March 2009  
FL545A-C  
NHTSA #09V-024  
REVISED NOTICE

## Subject: Cascadia Cab and Chassis SAMs

**Models Affected: Specific Freightliner Cascadia vehicles manufactured with signal-detect and activation modules (SAMs) between February 20, 2006, and December 15, 2008**

**REVISIONS:** In step 26 of the Work Instructions, the size of the waterproof repair tape patch has been changed. Cab leak tests should be performed **only** if extensive corrosion is found in the SAM cab or SAM chassis or if there is evidence of an obvious leak path. If the SAMs are not corroded or there is no evidence of a leak path, those repairs are a separate issue and should not be filed under the recall.

**Fig. 12, Frontwall Holes**

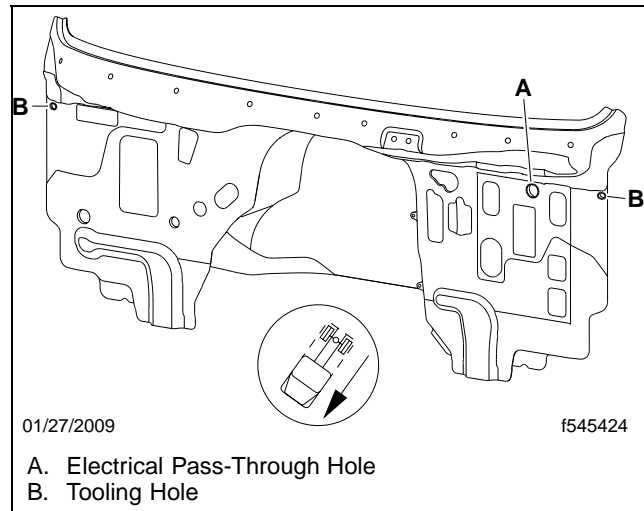
24. Remove the existing sealant tape, if present, from all three holes in the frontwall.
25. Using a solvent such as a brake parts cleaner, clean the area around each hole.
26. Use new, foil-faced, waterproof tape (such as Polyken 360-35 heavy duty, waterproofing repair tape) to create new sealing patches. Cut two 1-1/2-inch x 2-inch (38-mm x 50-mm) pieces of this tape for the tooling holes. Cut one 3-inch (76-mm) square piece for the electrical pass-through hole above the clutch. Seal the holes, making sure the tape is flat and smooth against the surface of the frontwall. Frontwall sealing patch (p/n 18-46891-000) may also be used to reseal the hole above the clutch assembly.
